ENGINEER'S CERTIFICATION NOTES

GOLDEN VENTURES
DETAILS AND PROFILES

GOLDEN VENTURES
GRADING AND DRAINAGE PLAN

**KARSTEN EXPANSION
GRADING AND DRAINAGE PLAN**

POND VOLUME CALCULATIONS

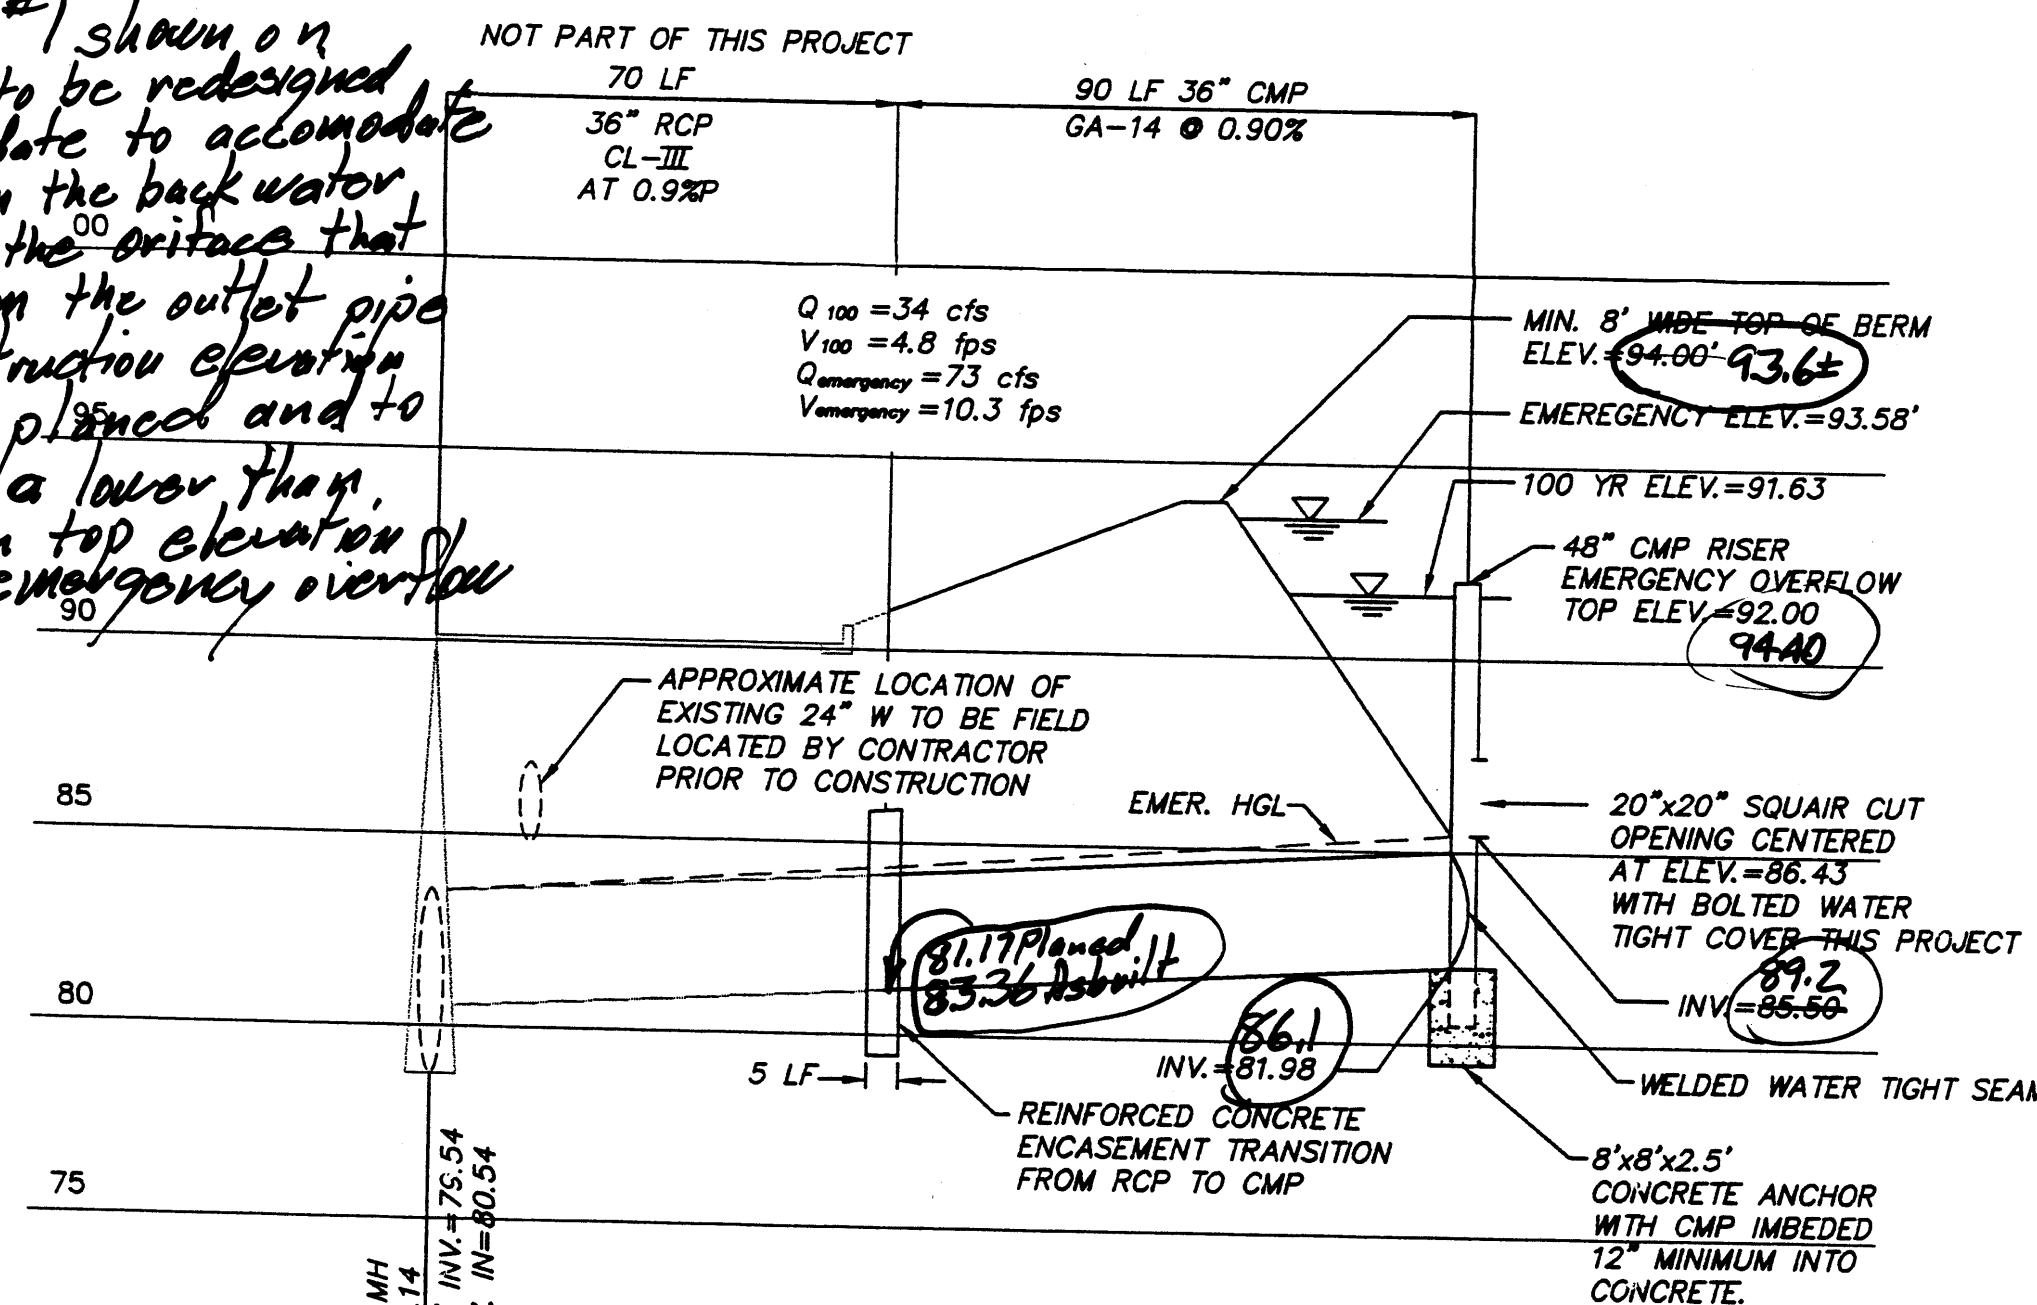
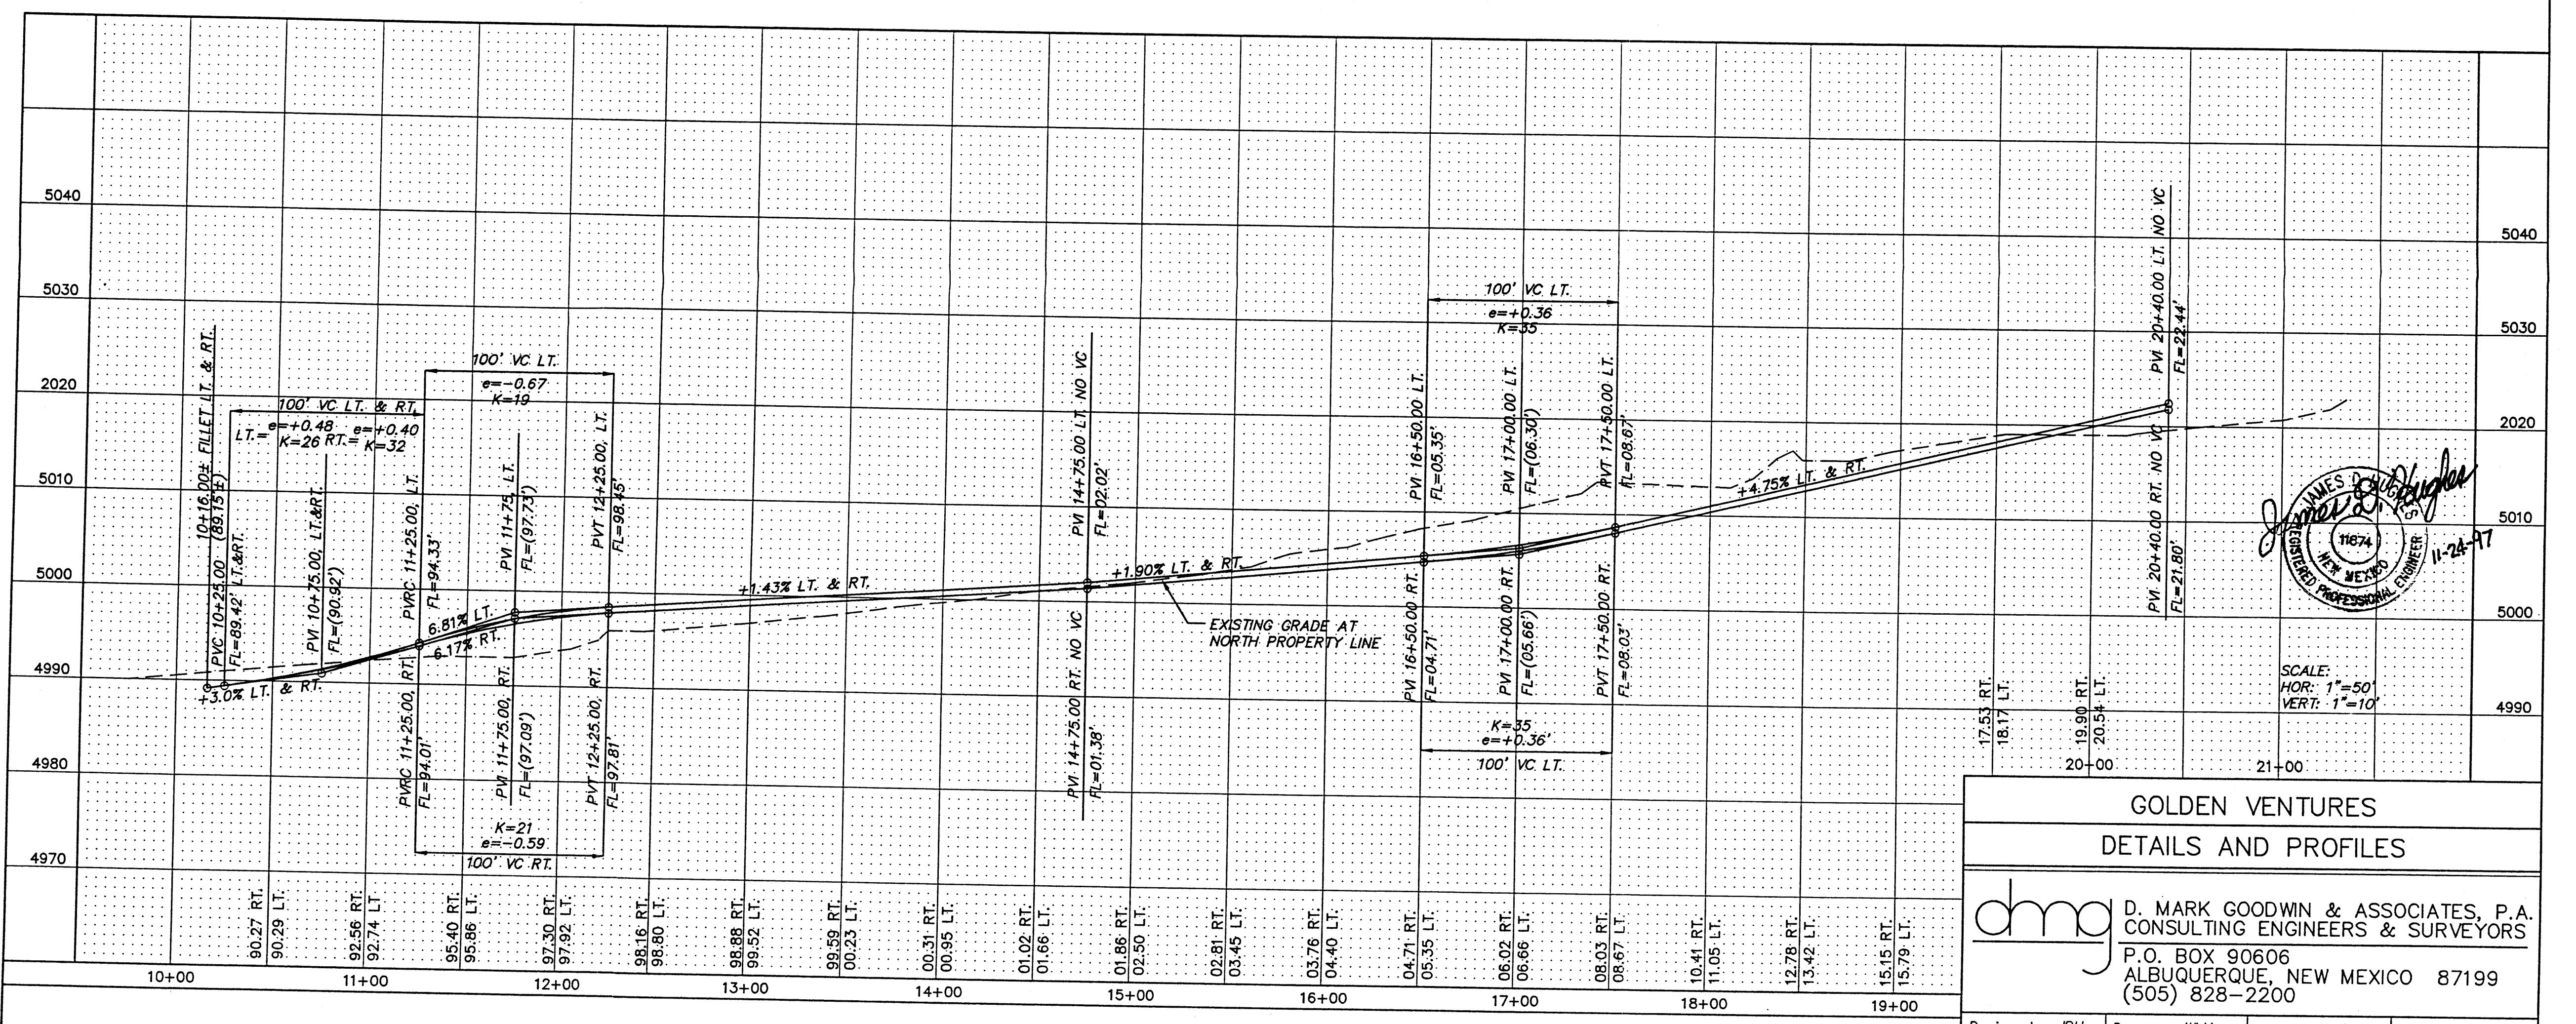
Pond #3 As-built OK 7-14-98

As-built Note:
 Future pond #1 shown on Sheet #1 is to be redesigned at a later date to accommodate the change in the backwater pressure on the outlet pipe. As-built construction slightly higher than planned and to decommodate a lower than planned dam top elevation and lower emergency overflow view.
